Access Compliance Report

Public Rights-of-Way

Intersection ID: 44420	Main Street: PROVIDENCE PROMENADE DR S	Cross Street: PROVIDENCE PROMENADE DR S	Location: SE
ADA ID: 3C1219CB39D3	Ramp Type: Perp	Initial Pass/Fail: Fail	Overall Compliance: No
Severity Score: 12.5			
Codes/Mitigation Info/Possible Solution		Field Measurements/Component Compliance

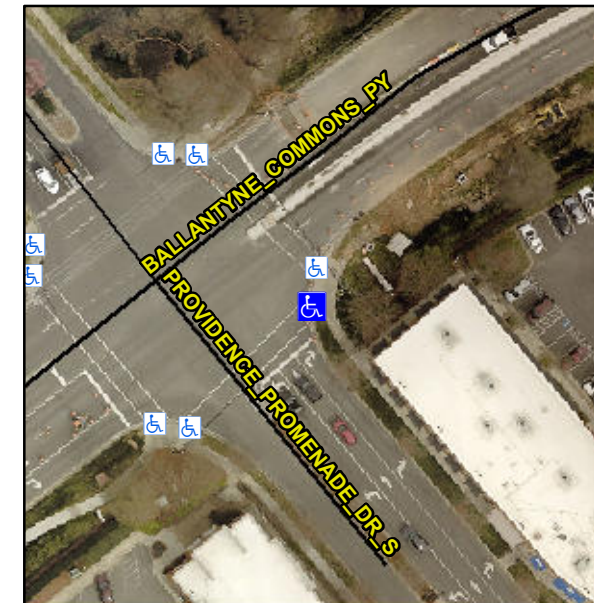
Not Found, R304.5.3

Compliance	Description	Data	Compliance	Description	Data
N/A	Ramp Length (in)	72.0	Yes	Ramp Slope (%)	5.2
Yes	Ramp Width (in)	51.0	No	Ramp XSlope (%)	5.4
N/A	Flare Type LT	N/A	N/A	Flare Type RT	N/A
N/A	Flare Slope LT (%)	N/A	N/A	Flare Slope RT (%)	N/A
N/A	Flare Traversable LT?	N/A	N/A	Flare Traversable RT?	N/A
N/A	Landing Length (in)	N/A	N/A	DWS Provided?	N/A
N/A	Landing Width (in)	N/A	N/A	DWS Contrast?	N/A
N/A	Landing Slope (%)	N/A	N/A	DWS Length (in)	N/A
N/A	Landing X Slope (%)	N/A	N/A	DWS Full Width?	N/A
N/A	Landing Curb? (Y/N)	N/A	N/A	DWS Offset (in)	N/A
N/A	Shared Landing?	N/A			
N/A	Gutter Ponding?	N/A	N/A	Gutter Slope (%)	N/A
N/A	Gutter Lip Ht (in)	N/A	N/A	Gutter X Slope (%)	N/A
N/A	Painted X Walk1?	Yes	N/A	Painted X Walk2?	N/A
	X Walk 1 Direction	To SW		X Walk 2 Direction	N/A
N/A	X Walk 1 Width (in)	113.0	N/A	X Walk 2 Width (in)	N/A
	X Walk 1 Slope (%)	2.0		X Walk 2 Slope (%)	N/A
	X Walk 1 X Slope (%)	3.5		X Walk 2 X Slope (%)	N/A

Remove & Replace Entire Ramp.
